IDENTIFICATION OF REFRACTORY MATERIAL FAILURES IN CEMENT KILNS CORRECTIONS

CORRECTIONS EXAMINER 1

CORRECTIONS EXAMINER 2

Figure 4-21. System MgO-Al₂O₃-K₂O ternary phase diagram at 1500 °C and 1 atmosphere for magnesia-fused spinel

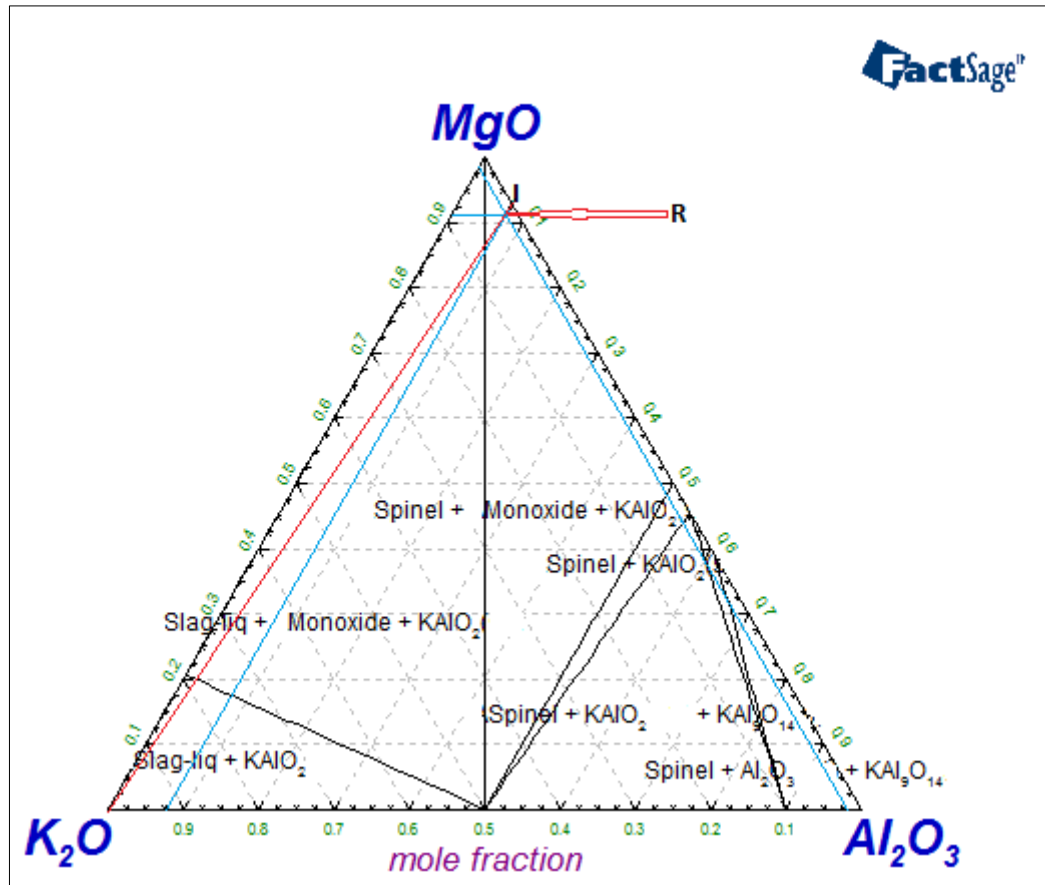
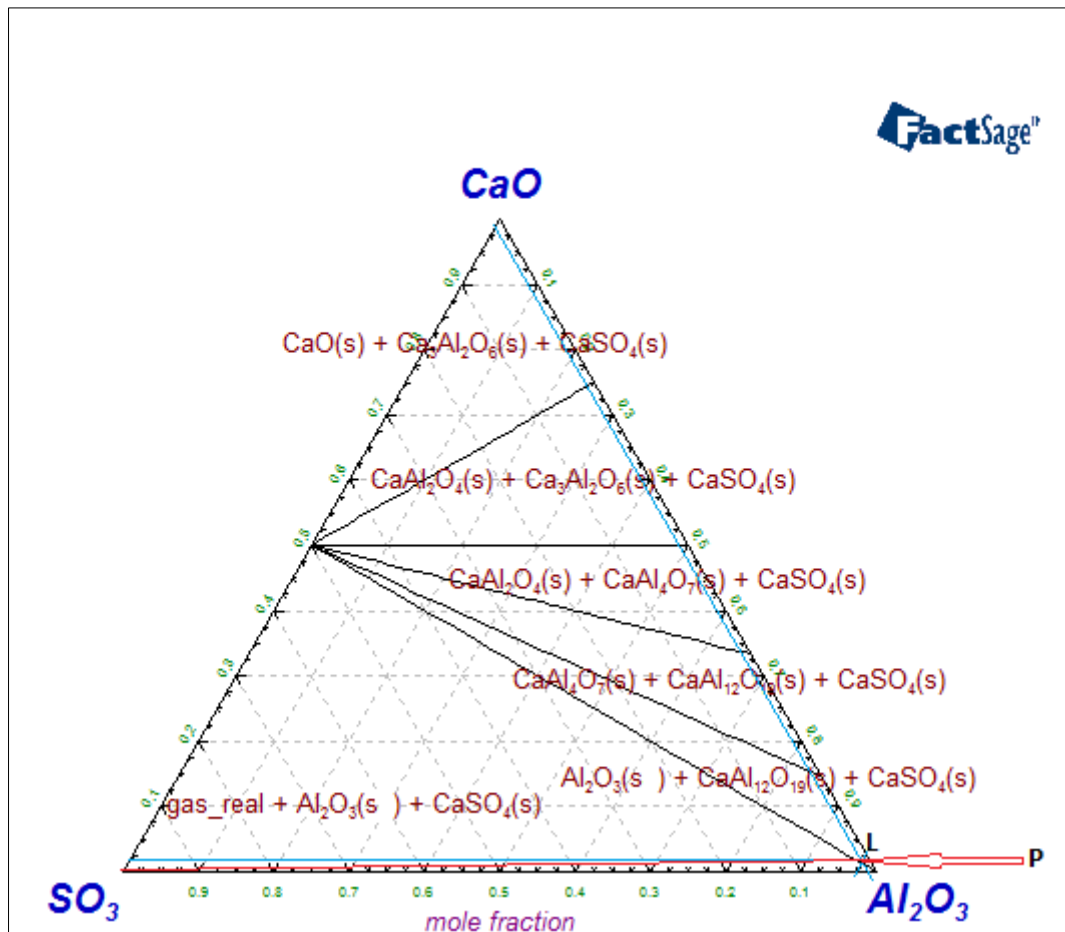
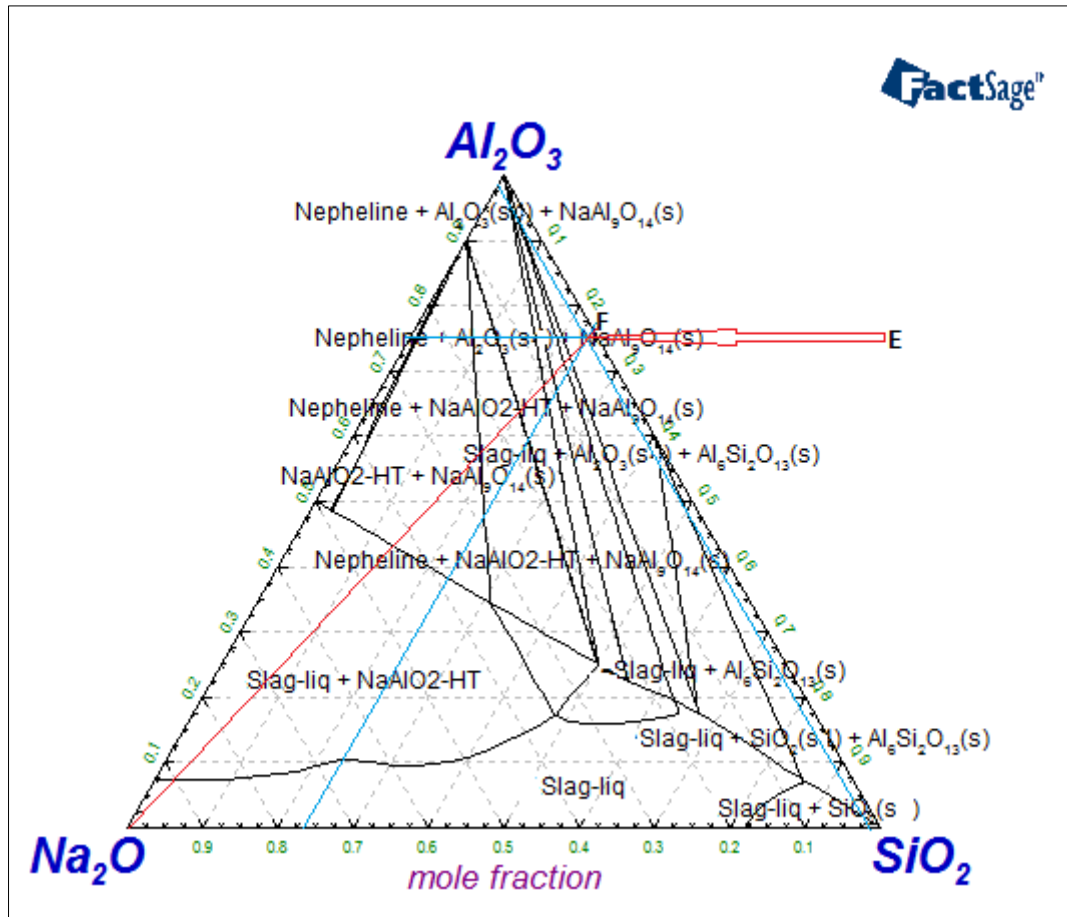
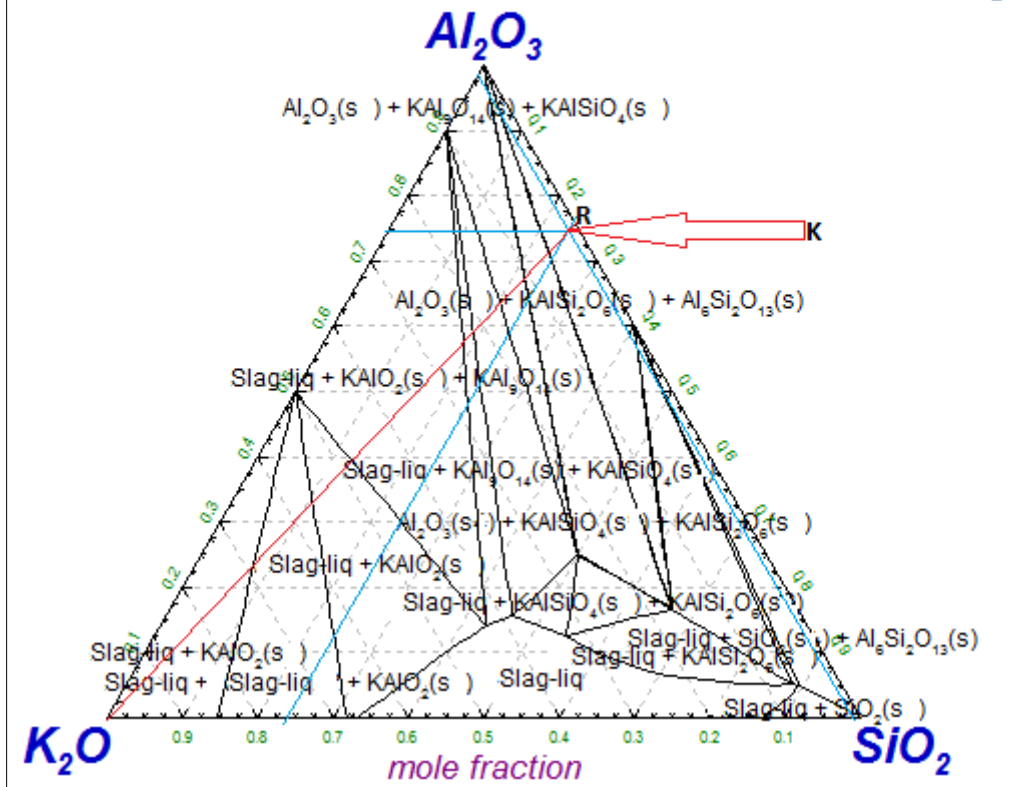
FactSage ternary diagrams. The graphics of all figures containing ternary diagrams generated by FactSage contain title information, which is repeated in the caption. Only the caption should be used, and not the title information in the graphic.

Corrected to the following:

Figure 4-18. System $\text{MgO}-\text{Al}_2\text{O}_3-\text{Na}_2\text{O}$ ternary phase diagram at 1500 °C and 1 atmosphere

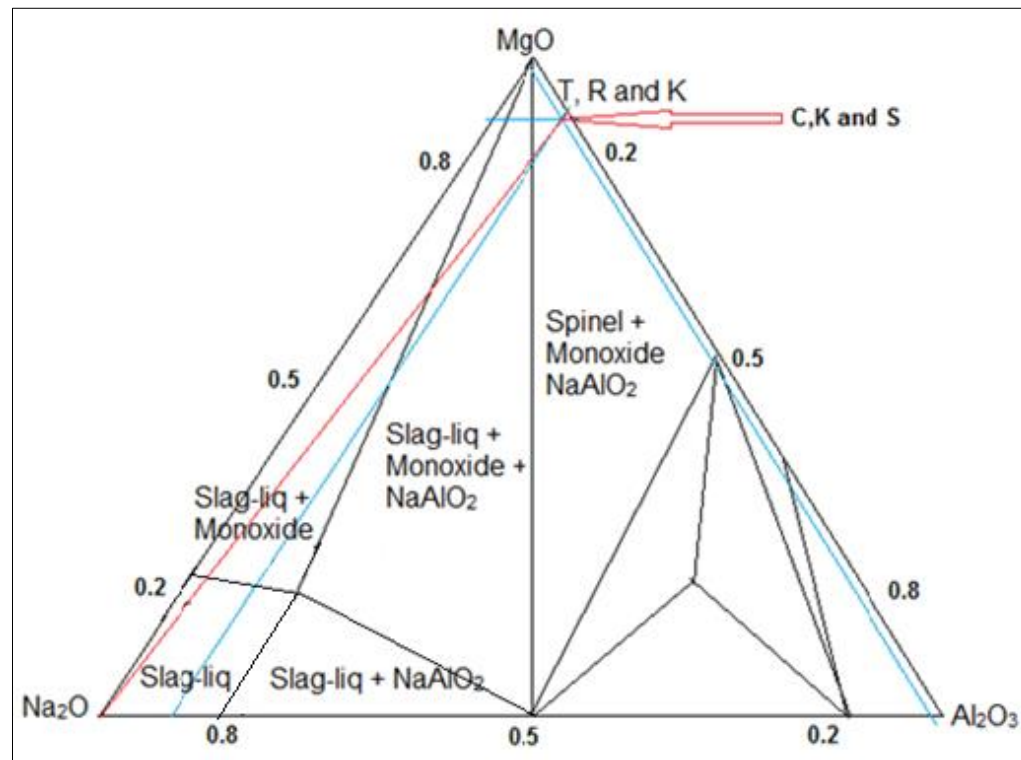
Phase region boundaries: The author constructed the ternary phase diagram in Figure 4-18. Two of the phase boundaries are incorrect. The first is the between the Slag + Monoxide + NaAlO_2 and Slag + NaAlO_2 phase regions. It is indicated as curved, while it should be a straight line.

The second boundary is the one between the slag + NaAlO_2 and slag regions. It is indicated as a straight line, while it should be curved. (p.92).

Figure A 1 High-alumina brick: used

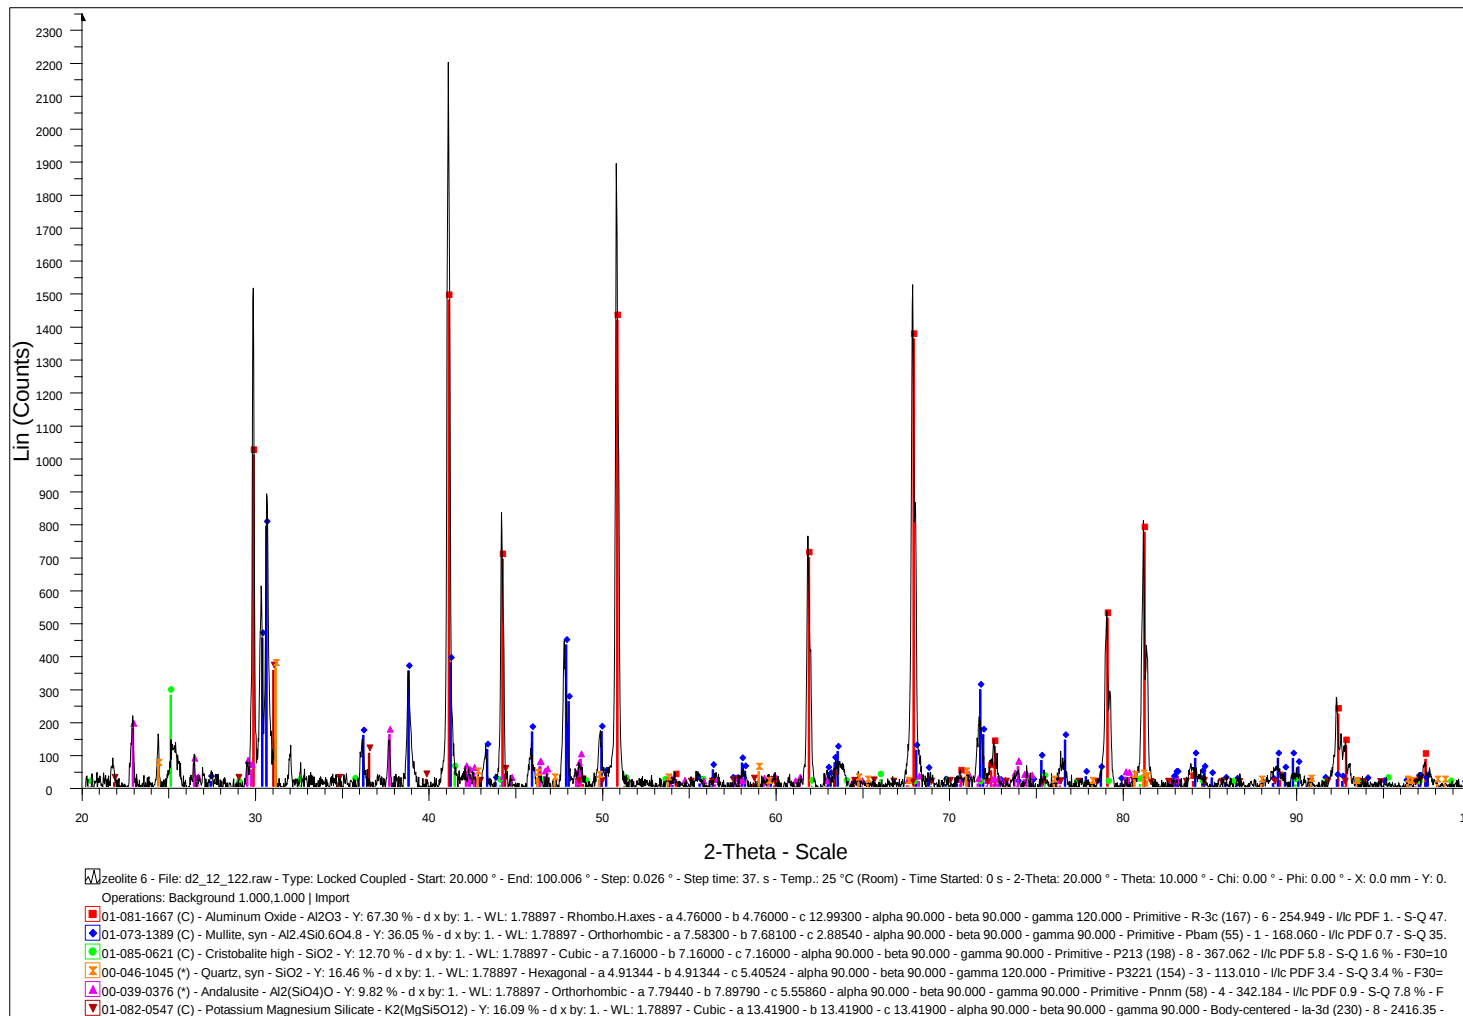
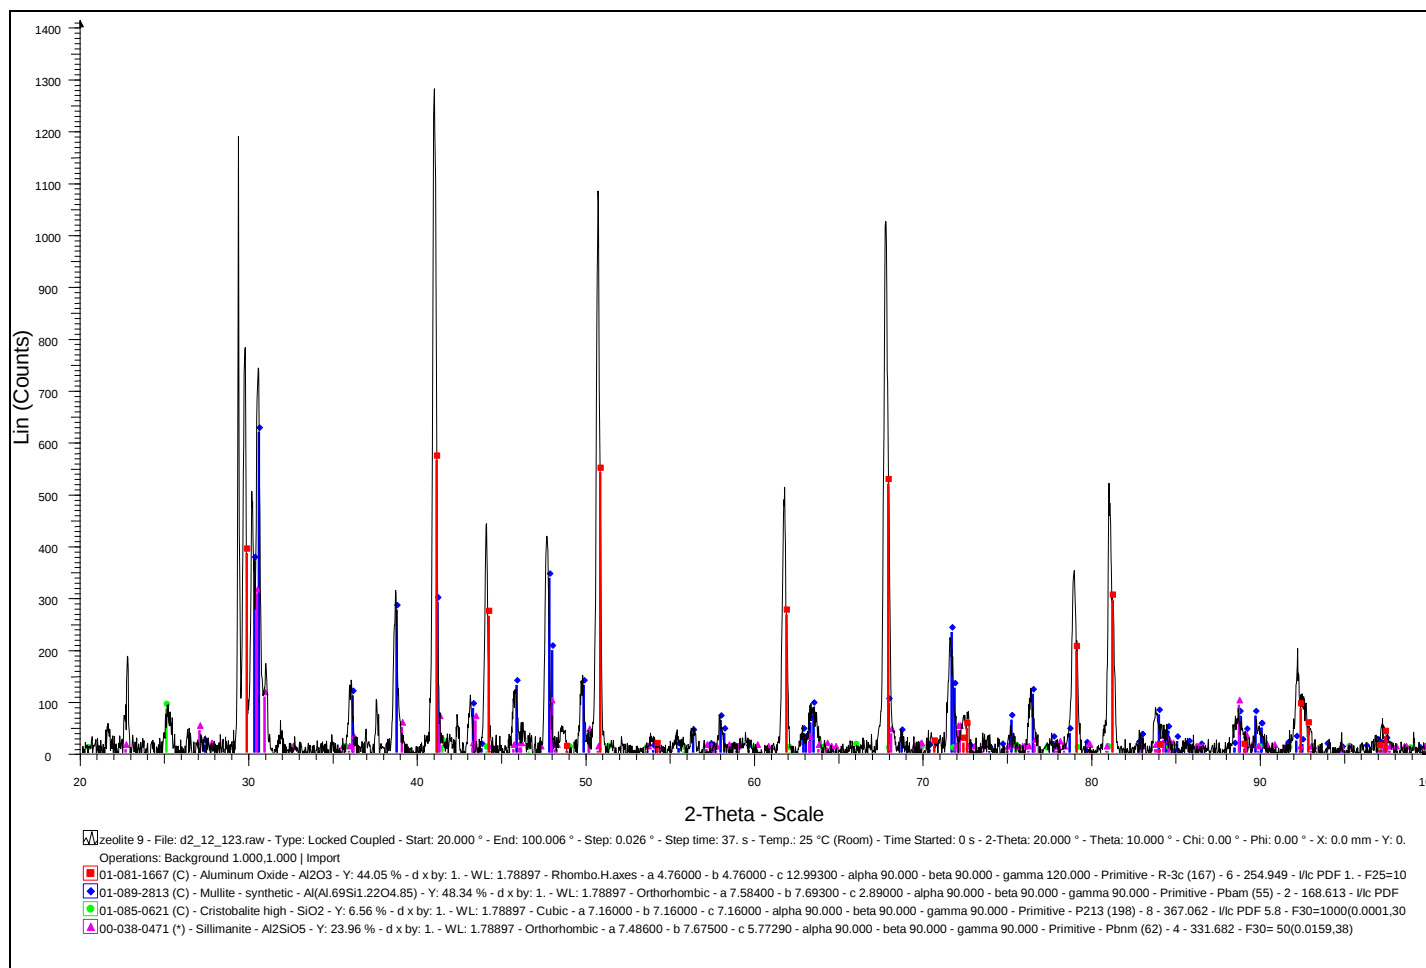
XRD results interpretation: In Table 5-3 on page 101 a nickel-titanium-silicon-oxide phase is identified. Based on the quantity of this phase (14.56%) it indicates that the refractory material contains approximately 8.5% nickel. This is in contrast with the XRF and SEM-EDS results that reported no nickel.
